DEPARTMENT OF PUBLIC WORKS
CONSTRUCTION PLAN FOR: GRADING, & STORM SEWER

PIKE LAKE CHANNEL (COUNTY DITCH NO. 2) SPECIAL DRAINAGE STRUCTURE

ASBUILT PLAN CONFORMING TO CONST. RECORDS

SHEET NO. 7 OF 7 SHEETS

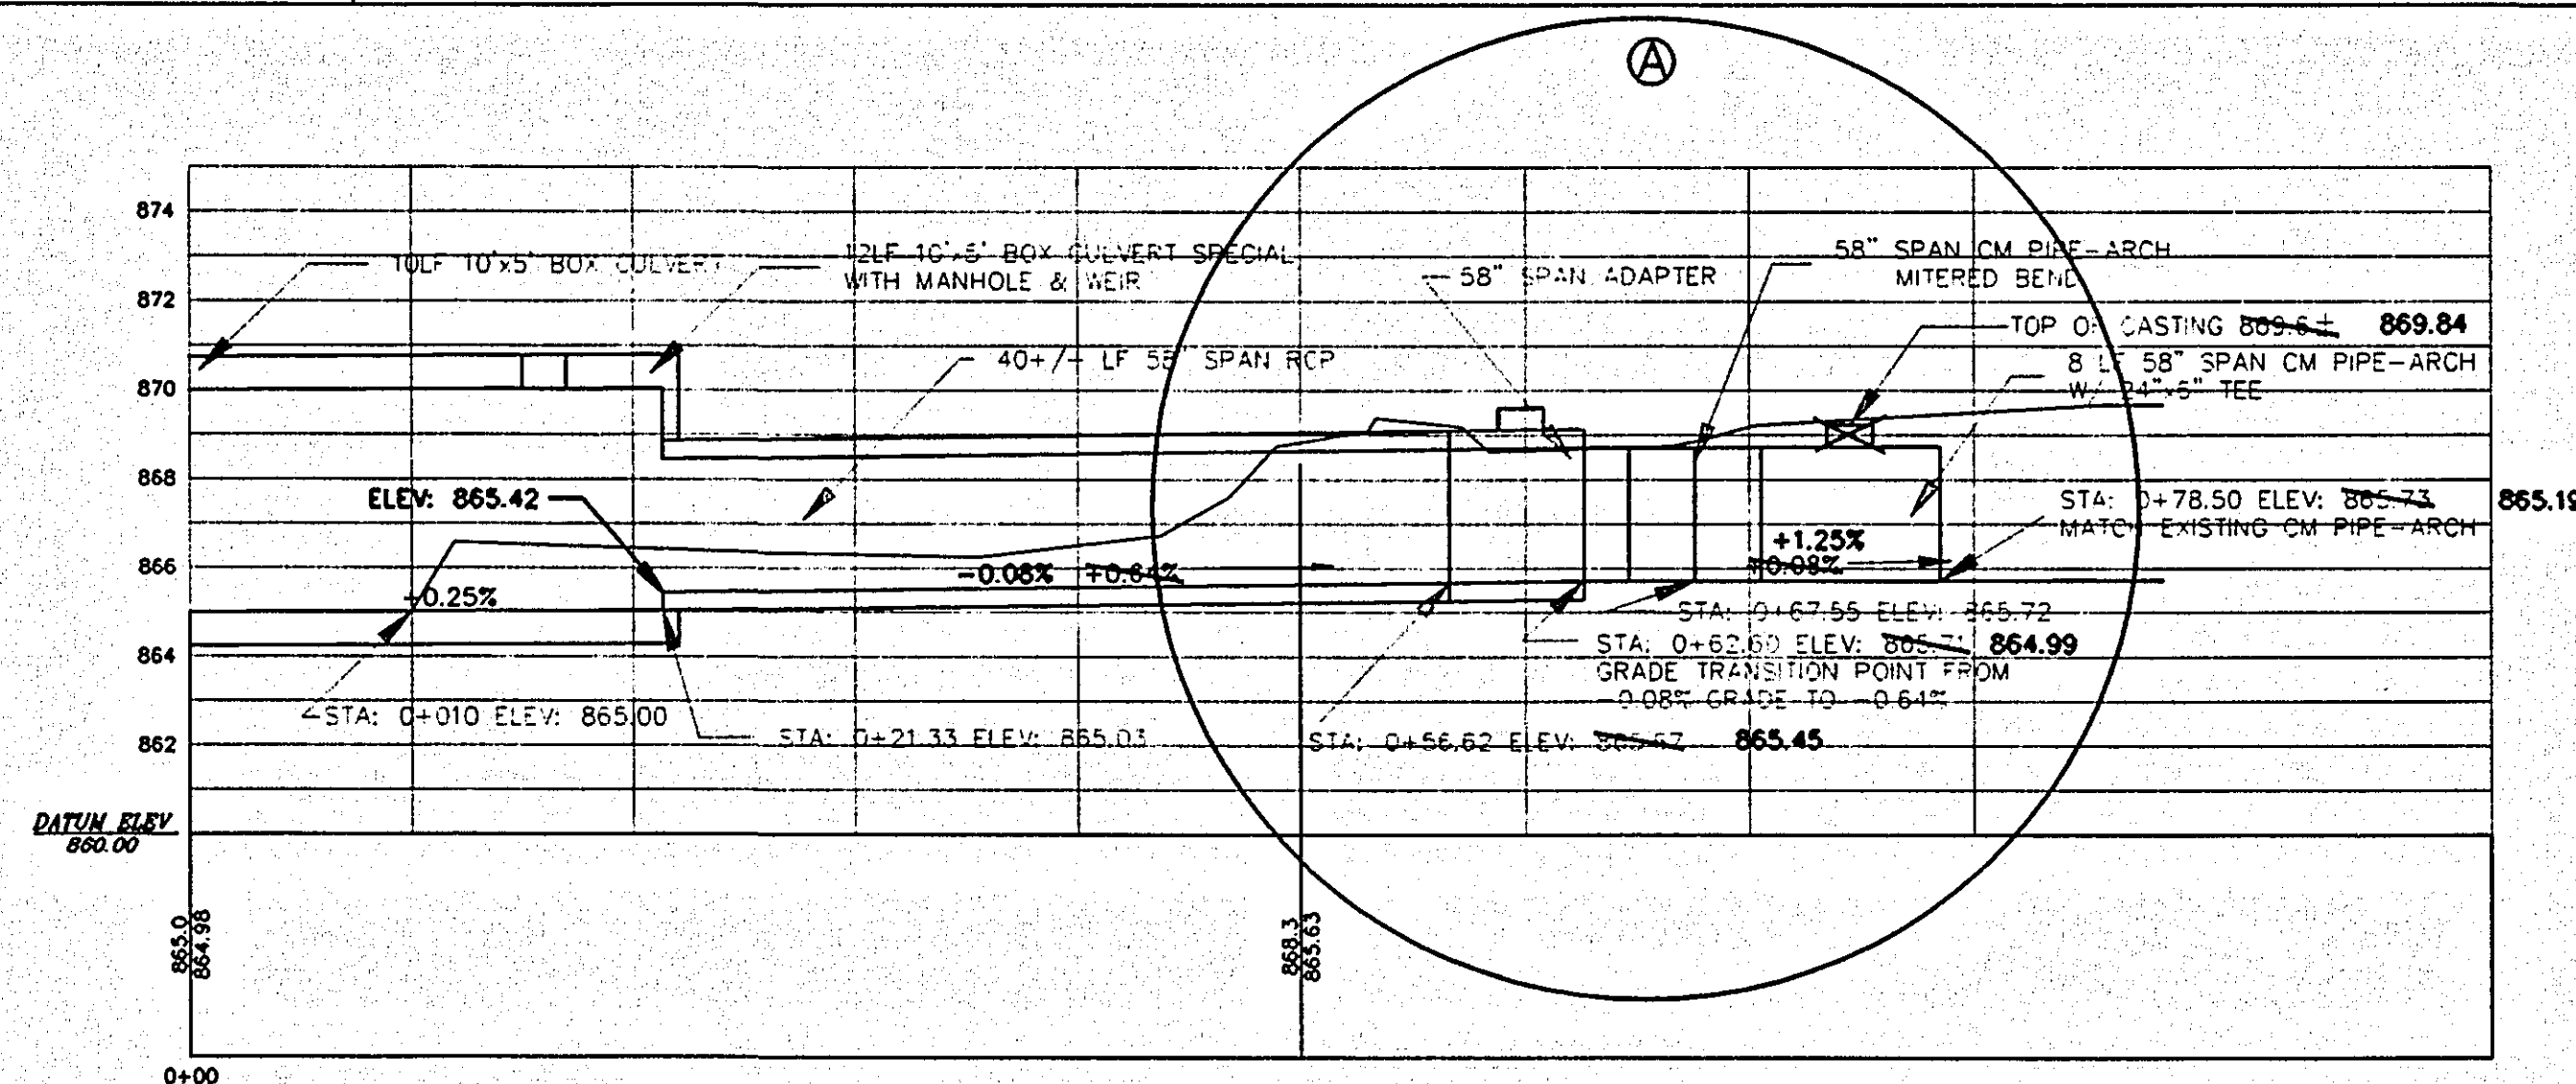
NOTE: (A)
EXISTING CMP APRON WAS REMOVED AND MH/CLEANOUT
WAS CONSTRUCTED DOWNSTREAM OF MITRED BEND
MH WAS CONSTRUCTED WITH A 0.54% SLUMP BECAUSE
EXISTING PIPE GRADE WAS NOT AS SHOWN. PIPE
SETTLED AFTER IT WAS ORIGINALLY INSTALLED
